Amendments to the Drawings:

REMARKS AND ARGUMENTS

Joel S. Hochman, et al

FIG. 4

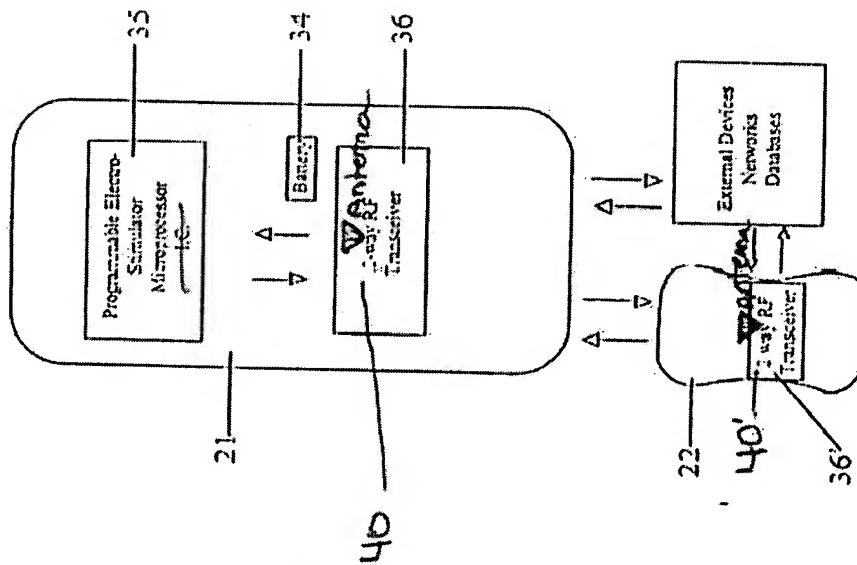
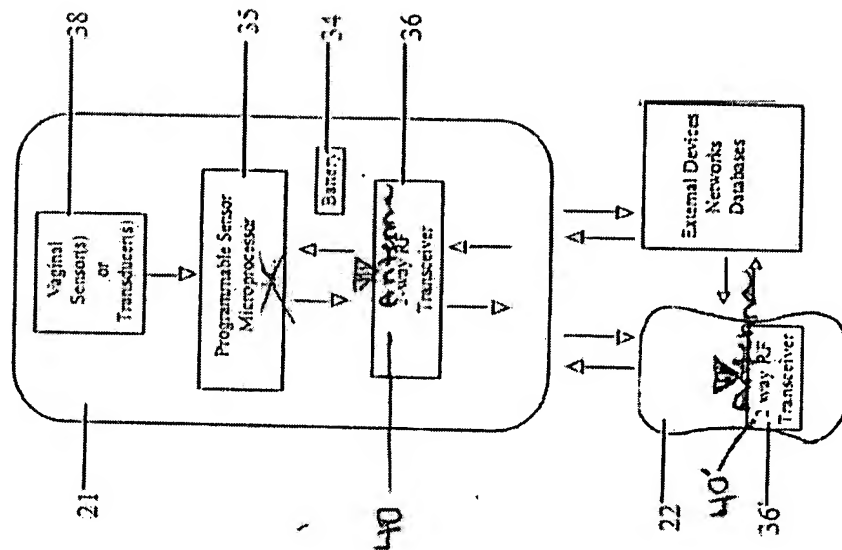
The attached sheet of drawings includes changes to Fig. 4, 5 and 6. These drawing sheets, which includes Figs. 4, 5 and 6, completely replace the original sheets including Figs 4, 5 and 6. In these Figs., omitted elements 40 and 40' have been added. In addition, some of the wording has changed within the drawings.

Three replacement drawing sheets in compliance with 37 CFR § 1.121(d) are submitted herewith. Replacement Figures 4, 5, and 6 each show an antenna (40) as an element of the probe unit and an antenna (40') as an element of the control unit.

Additionally, in each of the replacement drawing sheets, "I.C." has been deleted from the label of the representation of the microprocessor (35) of the probe unit (21) because this part of the label was not sufficiently explained in the written description.
